JL Colter Letter of December 27, 2002

NWIRP Bethpage, New York

Enclosure 1 - Navy Responses to NYSDEC Comments on
Petition to Modify Boundaries

**COMMENT RESPONSES FROM ENGINEERING FIELD ACTIVITY, NORTHEAST
REGARDING PETITION TO MODIFY NAVAL WEAPONS INDUSTRIAL RESERVE PLANT
SITE ID #130003B**

DRAWING NO. **FIGURE 1** REV. 0

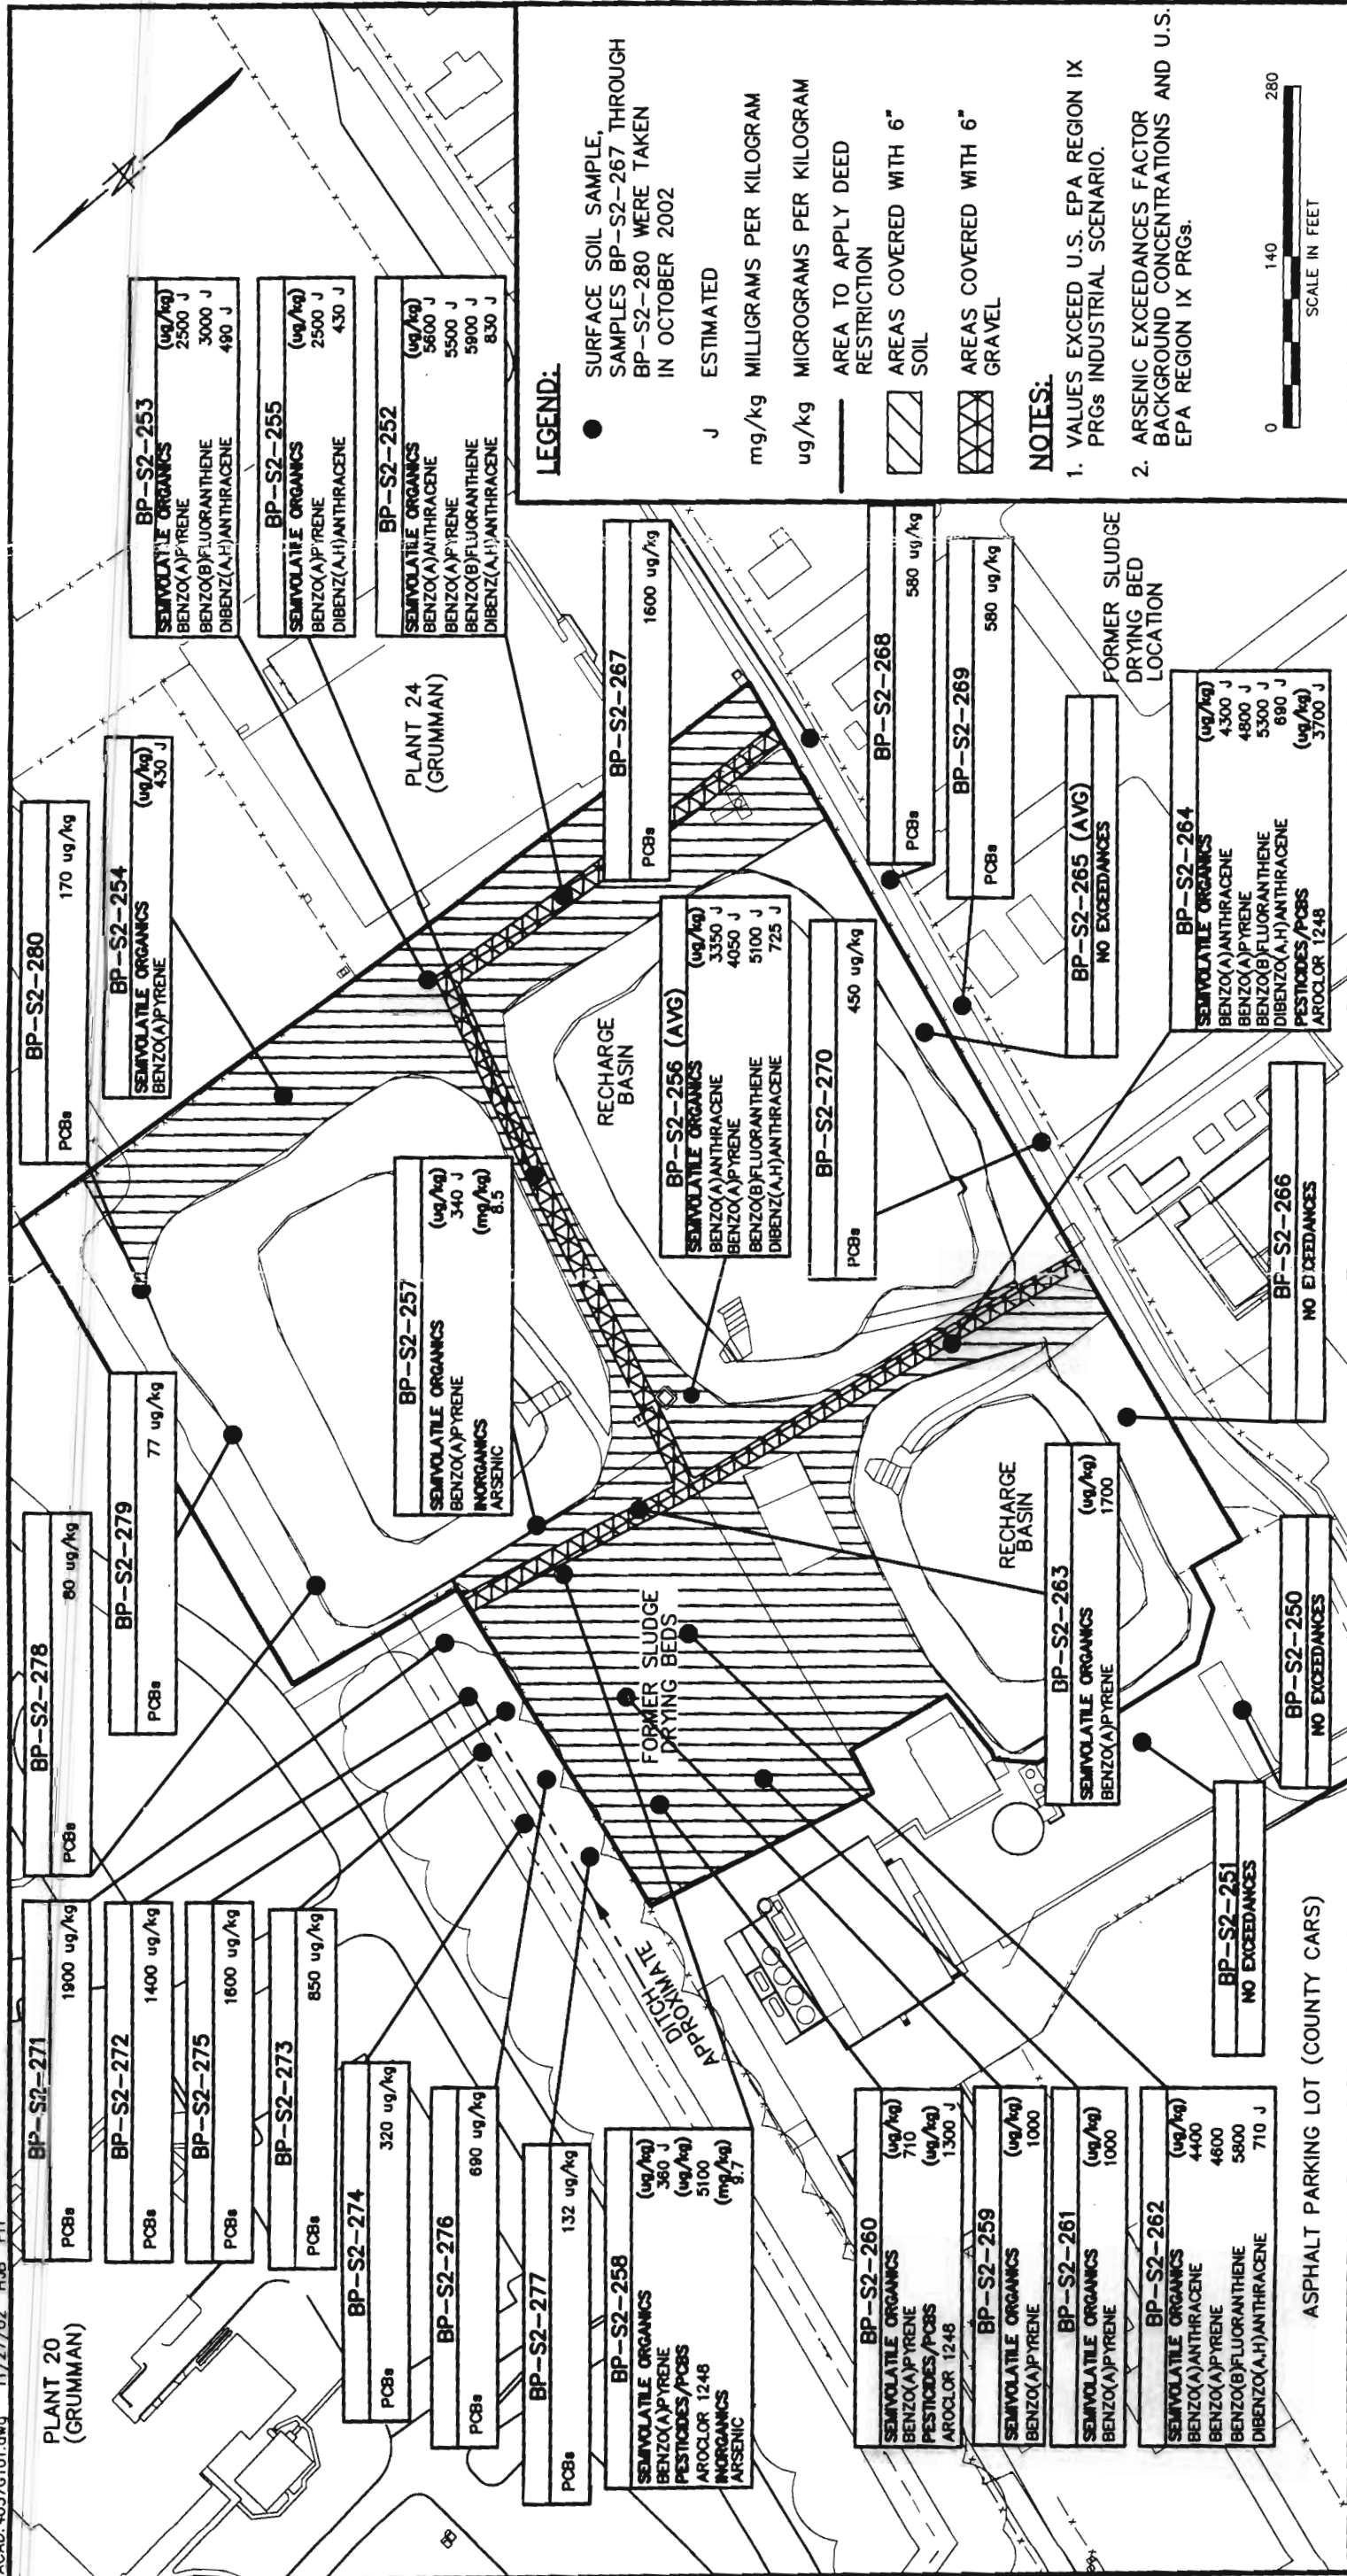
4. **Comment:** Appendix A of the Construction Completion Report contains surface soil sampling results from Sites 2 and 3. Delineation of PCB-contaminated soil around the perimeter of each Site must be done to levels of less than 1 milligram per kilogram (mg/kg or ppm). This level of delineation appears to be sufficiently achieved for Site 3 and for the eastern and western lot lines of Site 2. Additional surface soil sampling (0-2") should be done at the north fenceline of Site 2 and along the grassy strip immediately south of the access road at the southern part of Site 2. For consistency with the ongoing off-site PCB surface soil investigations along the access road, one surface soil sample should be collected in the grassy strip opposite each of the four residential properties.

Response: As requested, the Navy collected additional surface soil samples from the referenced areas. Please note that the soils were collected in the depth range of generally 0 to 4 inches, consistent with the normal definition of surface soils.

The results are attached, and are summarized as follows.

Grassy Strip along Fence South of Recharge Basins: PCBs were detected in four of four samples at concentrations ranging from 0.45 mg/kg to 1.60 mg/kg. The average PCB concentration of these four samples is 0.80 mg/kg, which is less than the industrial cleanup standard for the site of 10 mg/kg, as well as a residential cleanup standard of 1.0 mg/kg. Note that historically the Navy sampled three of the four residential properties south of the fence as part of a Site 1 investigation and did not find detectable concentrations of PCBs in these properties.

Wooded Area and Ditch North of Former Sludge Drying Beds: PCBs were detected in seven of seven samples at concentrations ranging from 0.132 mg/kg to 1.9 mg/kg. The average concentration of these seven samples is 1.0 mg/kg, which is less than the industrial cleanup standard for the site of 10 mg/kg, as well as a residential cleanup standard of 1.0 mg/kg.

Area North of Northeast Recharge Basin: PCBs were detected in three of three samples at concentrations ranging from 0.077 to 0.17 mg/kg. The average PCB concentration of these four samples is 0.11 mg/kg, which is less than the industrial cleanup standard for the site of 10 mg/kg, as well as a residential cleanup standard of 1.0 mg/kg.
